Request for Interpretation No. 68

AC Class Rule Version 1.8: November 18th 2016

Drawings ACC-1001-RevC CROSS STRUCTURE AREA, and ACC-11100-RevB MEDIA BAY GA

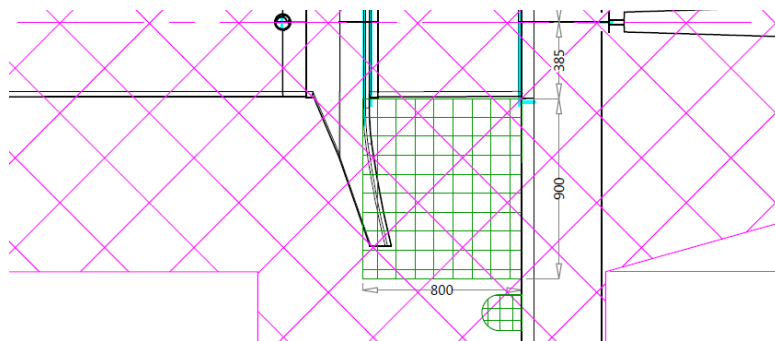
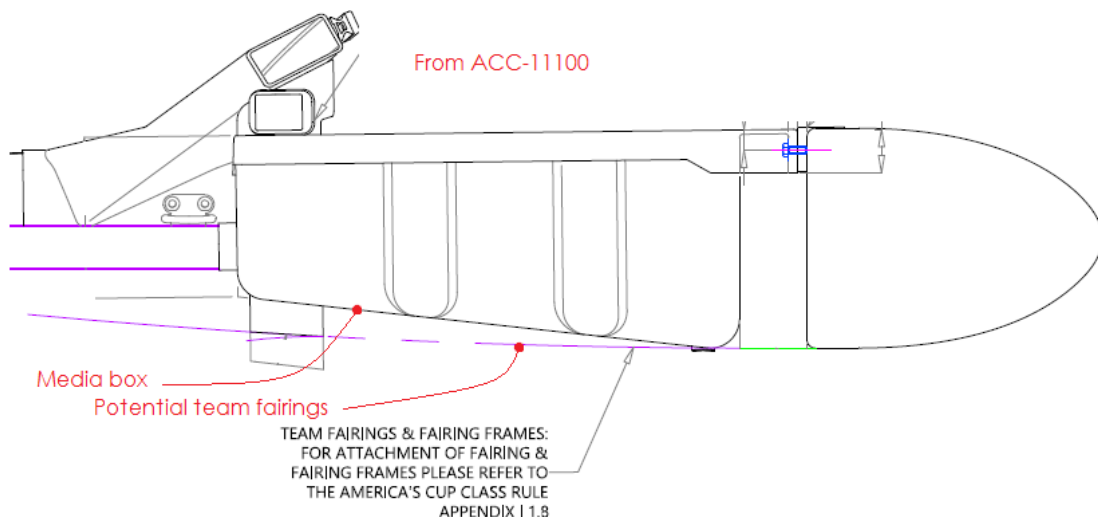
Drawing ACC-1001 has the following note about how to account for the areas reserved for media equipment in calculating the projected area of **cross structure** per Rule 8.5:

MAXIMUM AREAS RESERVED FOR MEDIA EQUIPMENT. CROSS STRUCTURE MUST ACCOMMODATE MEDIA EQUIPMENT PER APPENDIX I. THE MEDIA RESERVED AREAS, WHERE THEY OVERLAP WITH CROSS STRUCTURE, WILL NOT BE SUBTRACTED FROM THE PROJECTED AREA CALCULATION DESCRIBED IN RULE 8.5

Drawing ACC-1001 has two areas reserved for the MEDIA BAYS.

- 1) Rule 8.13 references “equipment lockers” and states that they will be specified in Appendix D, and that they will be part of the **cross structure**. There are no references to either "equipment lockers" or "media bays" in Appendix D. The only reference in Appendix D that might be linked to “equipment lockers” or the “media bays” is the reserved area in drawing ACC-1001 as shown above. Are the "equipment lockers" referenced in rule 8.13 the same thing as the "media bays" in drawing ACC-11100?

- 2) If the answer to 1) is yes, are the media bays considered part of the **cross structure** as stated in Rule 8.13, and therefore always included in the calculation of the projected area of **cross structure** per Rule 8.5?

- 3) If the answer to 2) is yes, if a team has an aerodynamic surface under the media bay like that shown in drawing ACC-11100 (see below), is the projected area of this aerodynamic surface, where it overlaps the projected area of the media bay, counted as additional projected area for purposes of Rule 8.5, as might be inferred from **interpretation 3**?

- 4) If the answer to 2) is no, and if a team does not install aerodynamic fairings under the media box, such that there is no "overlap with cross structure" as described in the ACC-1001 drawing note, may the projected area of the media box be subtracted from the projected area of **cross structure** calculation per Rule 8.5?

- 1) Yes. The “equipment lockers” indicated in Rule 8.13 are the same items now called “Media Bays” and described in drawing ACC-11100 MEDIA BAY GA.
- 2) Yes. The area of the Media Bays viewed orthogonal to **MWP** is included in the projected area calculation described in Rule 8.5.
- 3) No. Interpretation 3 ensures that the projected areas of completely independent aero/hydrodynamic bodies are added for the purposes of Rule 8.5. However, the projected areas of the upper and lower surfaces of a single aero/hydrodynamic body are not added together. For instance, the upper and lower surfaces of a conventional beam fairing will not be counted separately, as there is no significant aerodynamic flow between the two surfaces.
- 4) No, The Media Bays form part of the projected area of the **cross structure** and shall be always counted in the projected area calculation described in Rule 8.5.
